Access Compliance Report Public Rights-of-Way (Curb Ramps)

Main Street: MAGNOLIA_AVE Cross Street: MAGNOLIA_AVE Location: E

ADA ID: RPRK210921160751 Ramp Type: Type 4 - Parallel Initial Pass/Fail: Fail Overall Compliance: No Severity Score: 30

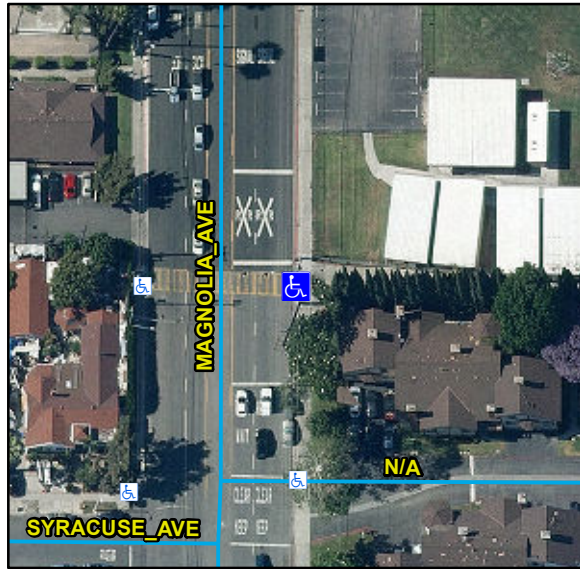
R304.5.3, STD 1115

Compliance	Description	Data	Compliance	Description	Data
N/A	Ramp Length LT (in)	87	N/A	Ramp Length RT (in)	85
Yes	Ramp Width LT (in)	96	Yes	Ramp Width RT (in)	97
Yes	Ramp Run Slope LT (%)	7.2	Yes	Ramp Run Slope RT (%)	7.2
No	Ramp Cross Slope LT (%)	7.8	No	Ramp Cross Slope RT (%)	4.4
N/A	Landing Present	N/A	N/A	DWS Provided	N/A
N/A	Landing Length (in)	N/A	N/A	DWS Contrast	N/A
N/A	Landing Width (in)	N/A	N/A	DWS Length (in)	N/A
N/A	Landing Run Slope (%)	N/A	N/A	DWS Full Width	N/A
N/A	Landing Cross Slope (%)	N/A		DWS Offset Type	N/A
N/A	Landing Movement Obstructed?	N/A	N/A	DWS Offset Left (in)	N/A
	Landing Movement Type	N/A	N/A	DWS Offset Right (in)	N/A
N/A	Landing Shared	N/A			
N/A	Clear Space	N/A			
N/A	Clear Space To Crosswalk (in)	N/A			
N/A	Marked Crosswalk 1	Yes	N/A	Marked Crosswalk 2	N/A
	Crossing 1 Direction	W		Crossing 2 Direction	N/A
	Marked Crosswalk 1 Width (in)	122		Marked Crosswalk 2 Width (in)	N/A

Remove & Replace Entire Ramp.
